UNITED STATES
NUCLEAR REGULATORY COMMISSION
WASHINGTON, D. C. 20555

SUBJECT: SINGLE LOOP OPERATION (TAC NOS. 71162, 72910, 72786, 72787)

RE: LIMERICK GENERATING STATION, UNIT 1

Amendment No. 30
License No. NPF-39

FIGURE 3.2.3-1a

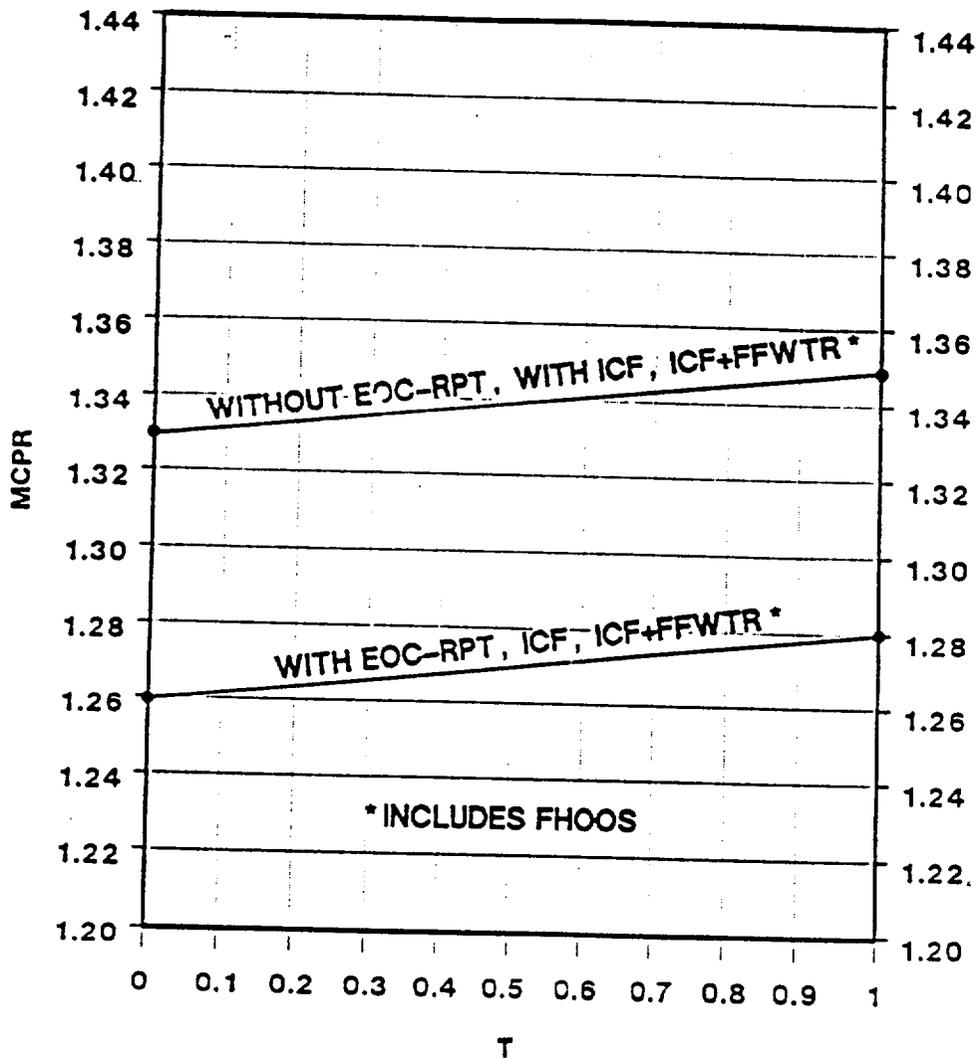
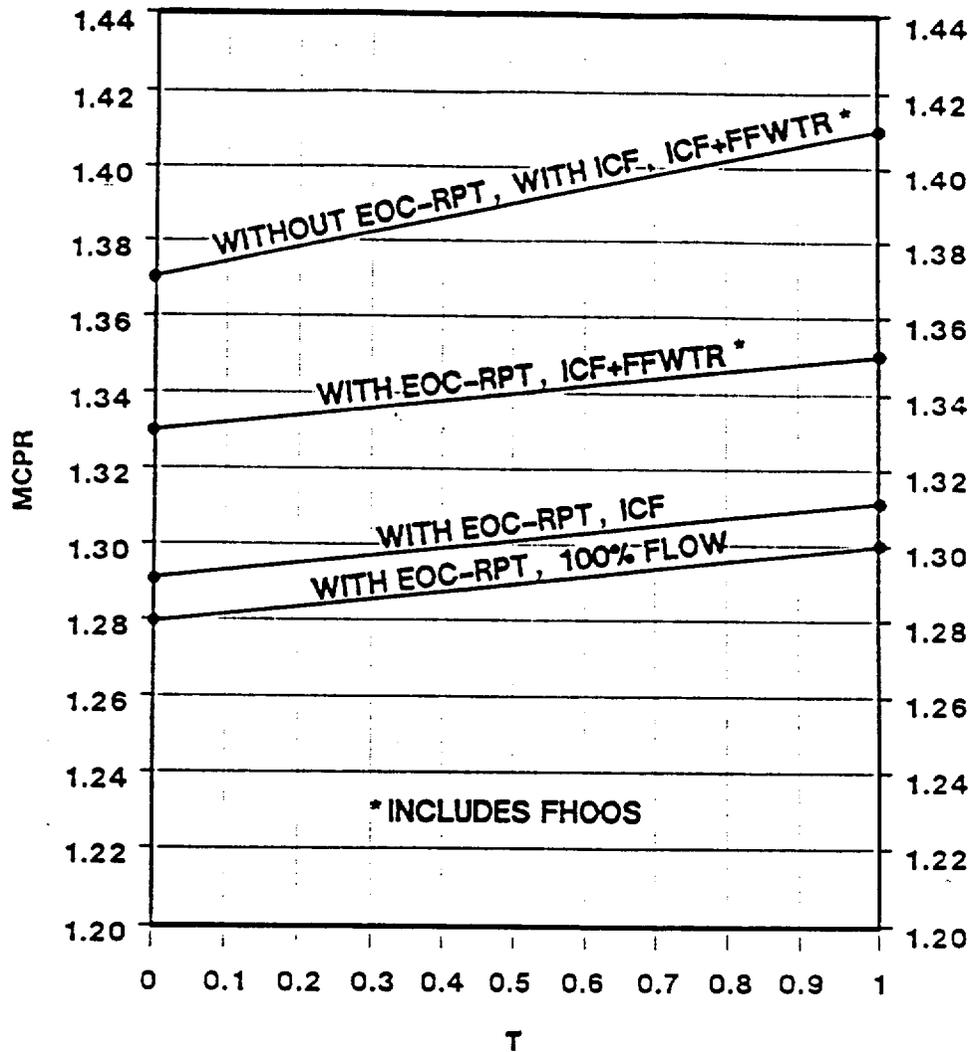
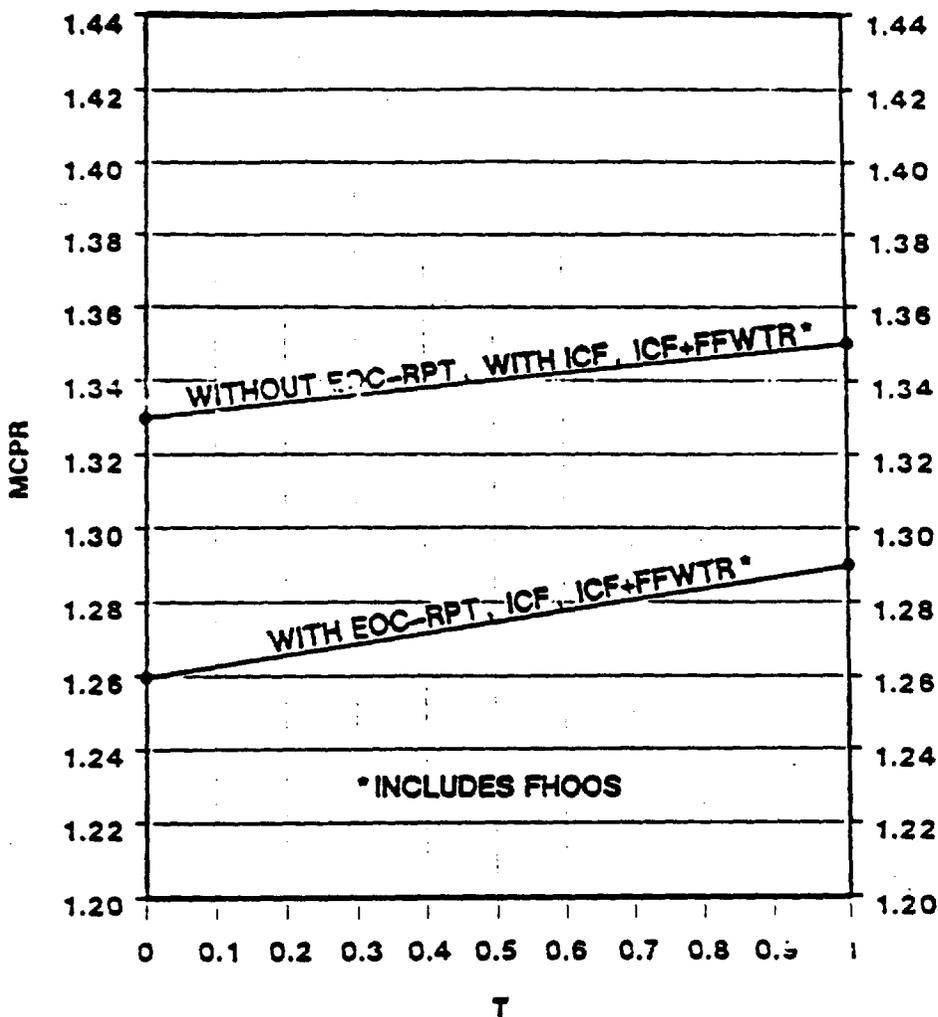
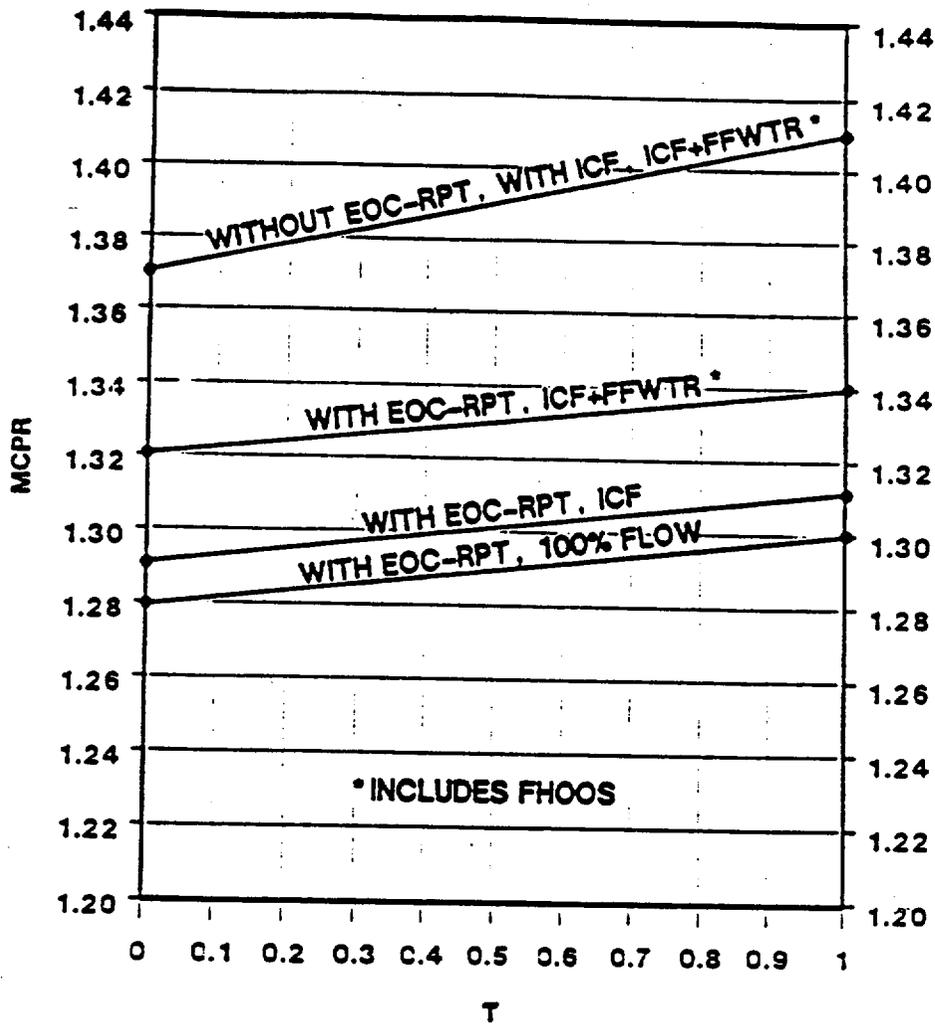
Figures 3.2.3-1a, b, c and d. - These are administrative changes adding a note to indicate that the figures apply to both SLO and TLO. They are acceptable. (Figures 3.2.3-1c and 3.2.3-1d were added to the TSs by Amendment No. 19 issued April 24, 1989. These figures did not exist at the time of the licensee's application. The figures all relate to MCPR limits and all were revised by Amendment 19 which imposed revised limits for the Cycle 3 reload. The note advises the reader that the curves are applicable for both dual and single recirculation loop operation. The addition is administrative and has no safety significance since it does not change anything.)

Note: These limits apply to Both Two Recirculation Loop and Single Recirculation Loop Operation.

Note: These limits apply to Both Two Recirculation Loop and Single Recirculation Loop Operation.

Note: These Limits Apply To Both Two Recirculation Loop and Single Recirculation Loop Operation.

Note: These Limits Apply To Both Two Recirculation Loop and Single Recirculation Loop Operation.

FIGURE 3.4.1.1-1

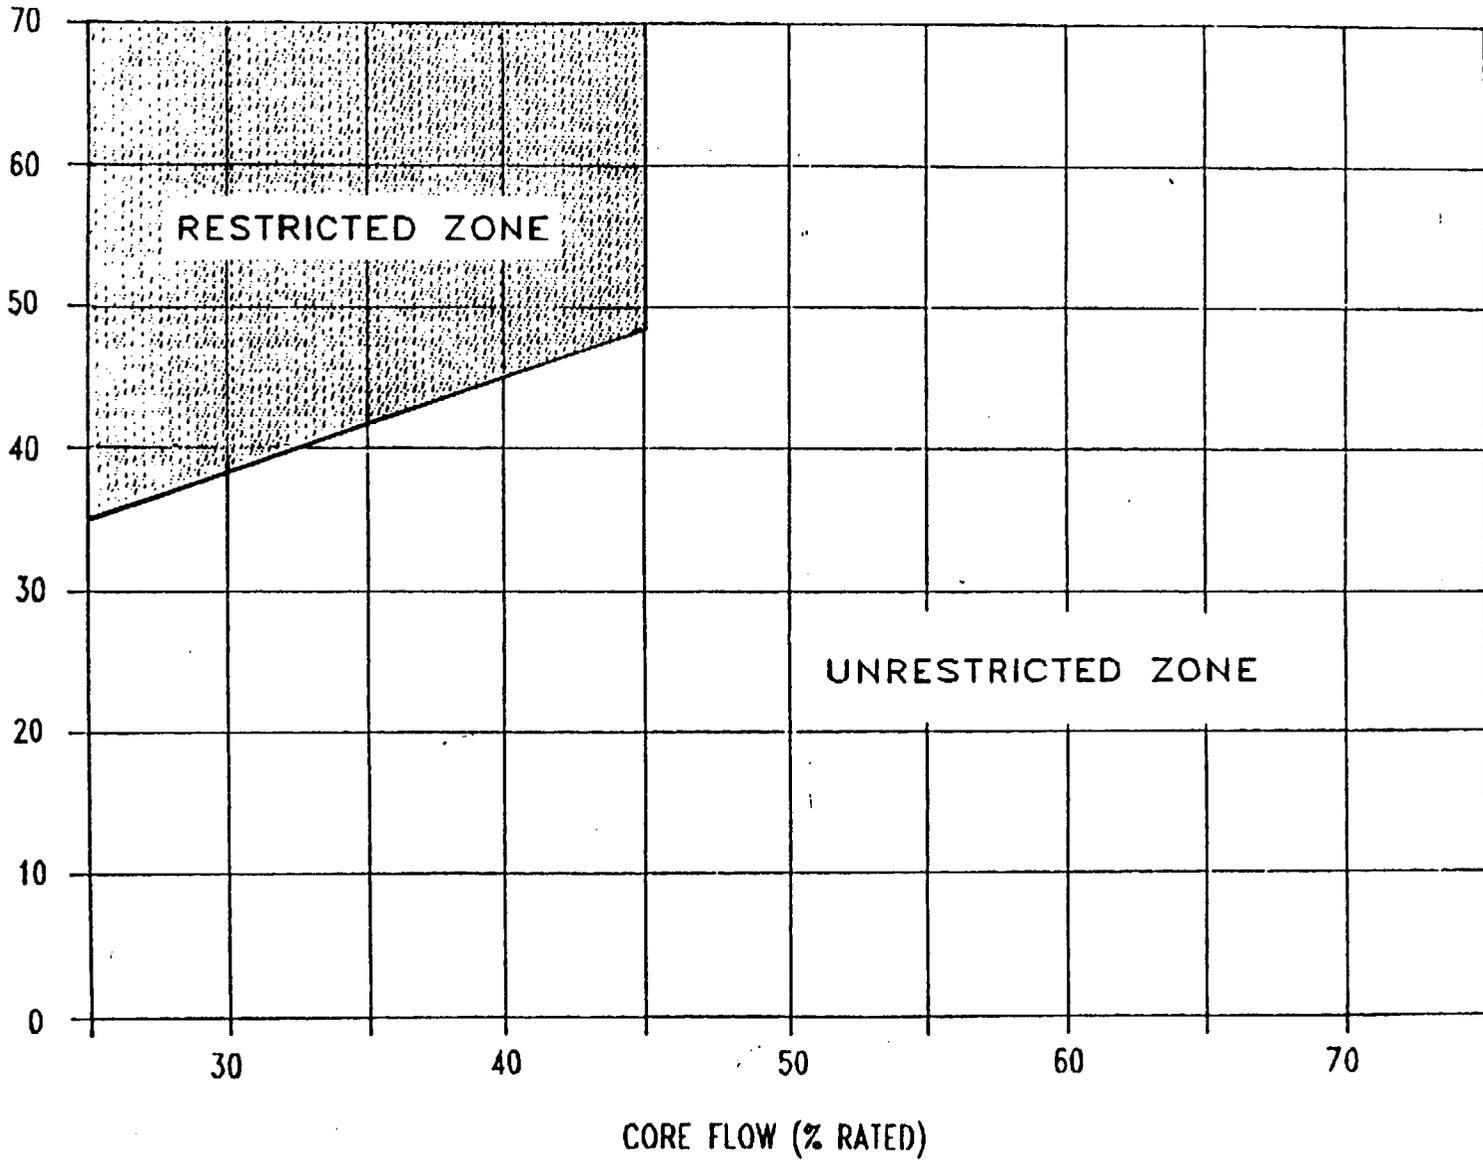
- c. With one or two reactor coolant system recirculation loops in operation and total core flow less than 45% but greater than 39% of rated core flow and THERMAL POWER within the restricted zone of Figure 3.4.1.1-1:

- d. With one or two reactor coolant system recirculation loops in operation and total core flow less than or equal to 39% and THERMAL POWER within the restricted zone of Figure 3.4.1.1-1, within 15 minutes initiate corrective action to reduce THERMAL POWER to within the unrestricted zone of Figure 3.4.1.1-1 or increase core flow to greater than 39% within 4 hours.
